THE CITY OF KEY WEST 3140 Flagler St, Key West, Florida 33040

ADDENDUM #4 Public Transit Facility Request for Proposal: 001-13 2 November 2012

CITY OF KEY WEST Public Transportation Facility Project Addendum No. 4 November 2, 2012

ADDENDUM #5 Public Transit Facility Request for Proposal: 001-13 20 November 2012

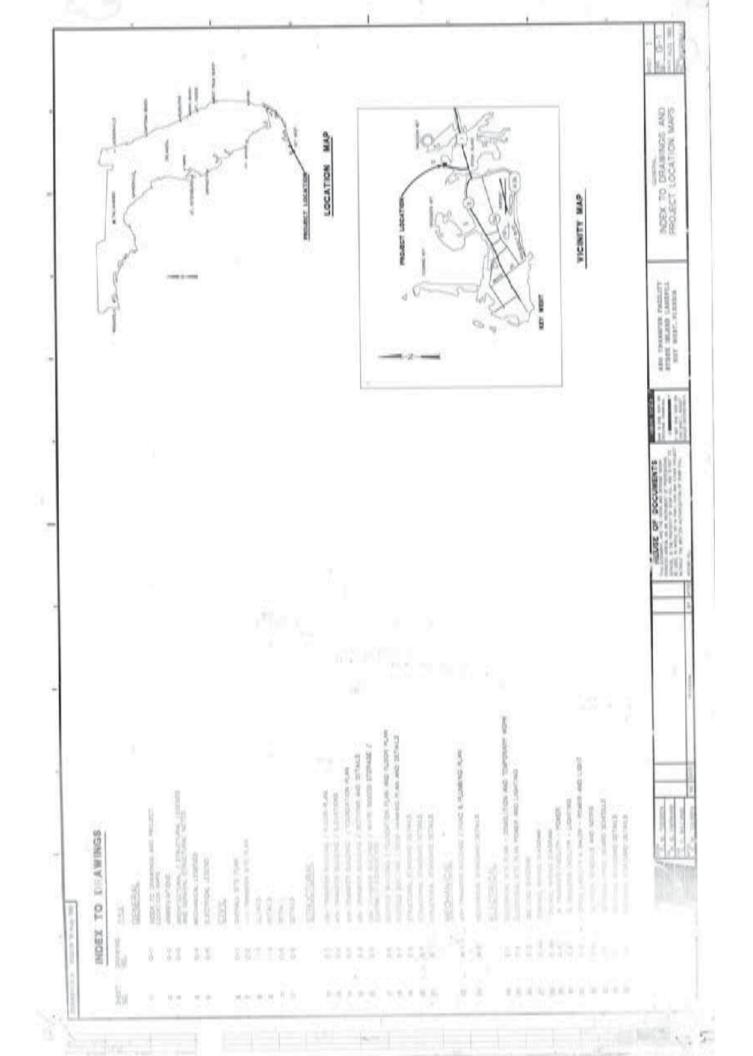
- A. Irrigation system is not required. Please refer to Section 6.2.9.
- **Q15.** Sheet LD-101 indicates a "Typical Roadway Buffer" with planting specification. This does not appear to match the planting shown on Sheet LD-100. Please indicate if we are

to follow the planting shown in plan, or if we are expected to provide the planting indicated in the detail.

- A. Design/Builder to follow the planting shown on plan.
- **Q16.** Is a survey of the site available? If not, will one be provided?
 - A. Design/Builder will be responsible for site survey.
